*TB 1-1520-243-20-31

DEPARTMENT OF THE ARMY TECHNICAL BULLETIN

OIL DEBRIS DETECTION SYSTEM (ODDS) CHIP DETECTOR FOR ALL AH-1 AND UH-1 SERIES AIRCRAFT

Headquarters, Department of the Army, Washington, D. C.
15 May 2002

Figure 1. VM2451001 Chip Detector with Self-Closing Valve Assembly

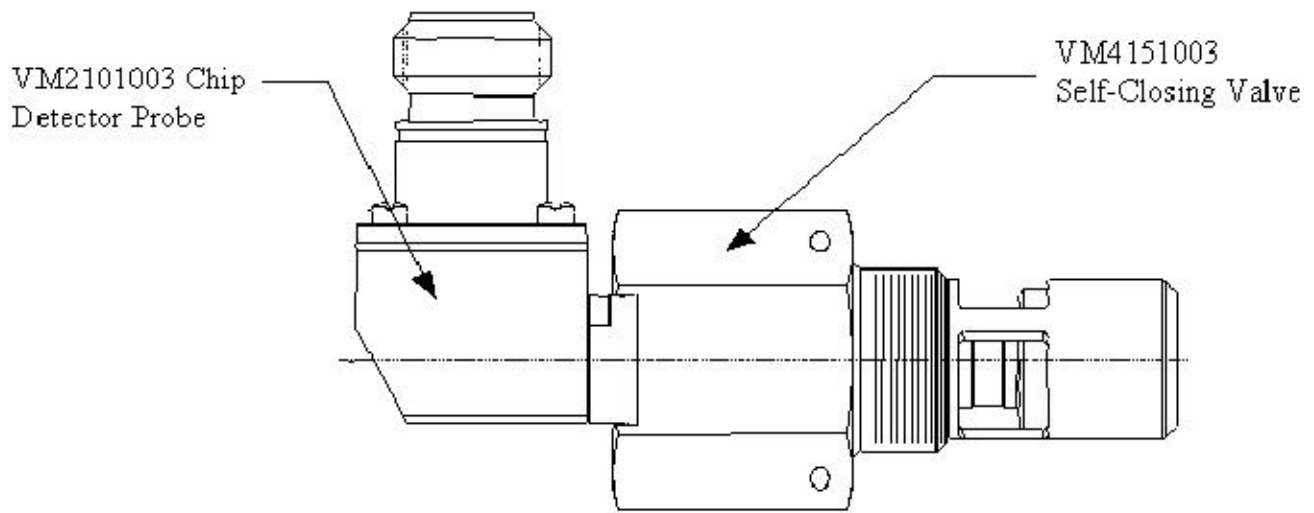
m. Inspect probe (Figure 2) blades and Chip Detector Valve (Figure 1) locking surface for wear. If either measure less than 0.027 inches, replace worn probe or valve.

Figure 2. VM 2101003 Chip Detector Probe

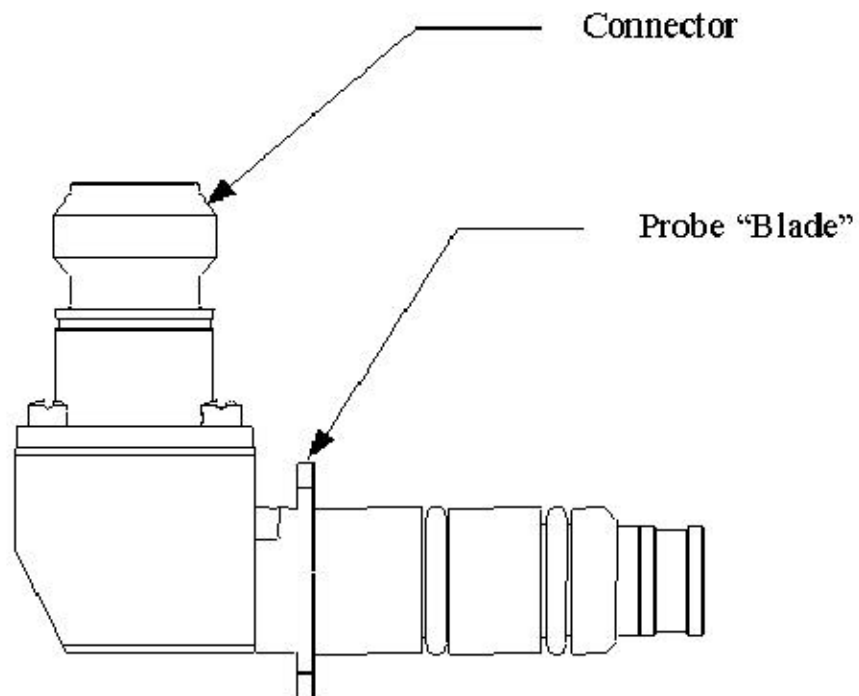
b. Install the Chip Detector Probe, P/N VM20101003, into the valve by lining up the "blades" (see Figure 2) on the probe with its corresponding slot in the valve. Push the probe into the valve until it will rotate in the clockwise direction. Rotate the probe 90 degrees in this direction until the probe "snaps back" and locks into place. Without pushing down, try to rotate the probe in either direction. The probe should be locked in place and move only slightly.

**Figure 3. Chip Detector Probe Installation
(probe shown in 12 to 3 o'clock positions)**

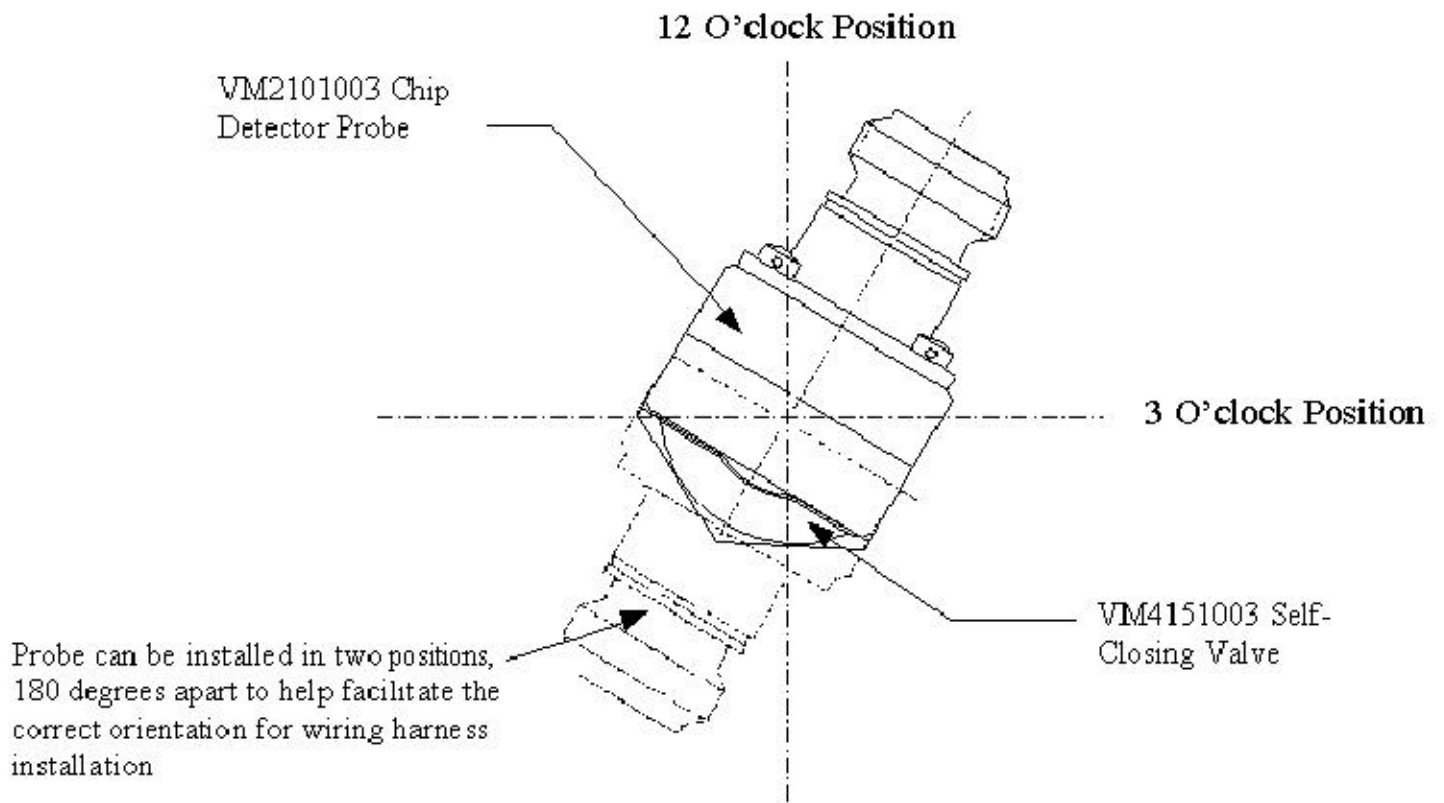
c. Check to make sure the probe's connector is orientated in the 12 to 3 o'clock position (see Figure 3) on the transmission in order to facilitate the wiring harness installation.

e. Reinstall the probe (per paragraph 9.b. above) 180 degrees (see Figure 3) from the first installation tried in paragraph 9.b. above.
